LiDAR Quality Assessment Report

UT_Brianhead_2018

2019-03-06

Project: UT_Brianhead_2018

Checkpoint Distribution Image

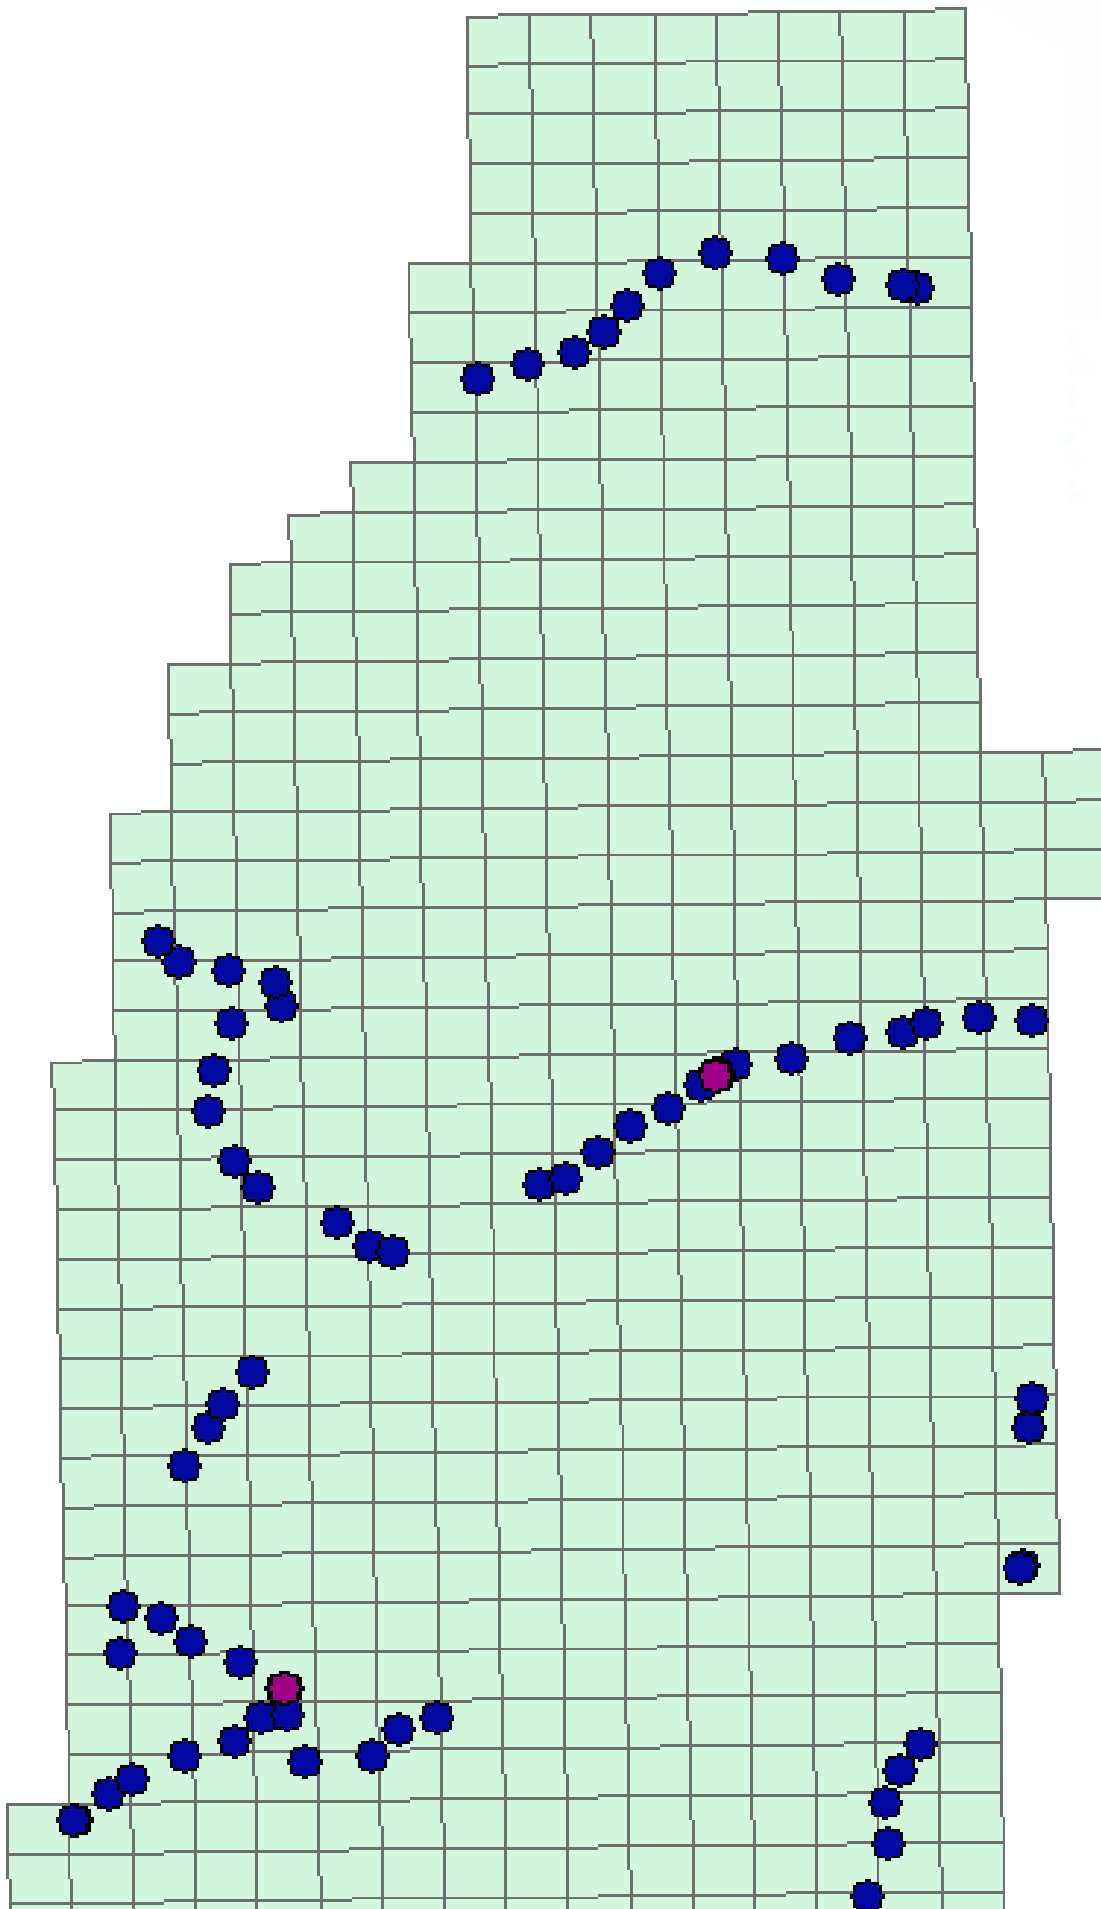
Checkpoints are well distributed? ☒

Enough checkpoints for task order? ☒

Checkpoints meet USGS LiDAR base-spec in quantity and quality? ☒

Based on this review, the USGS accepts the vertical accuracy.
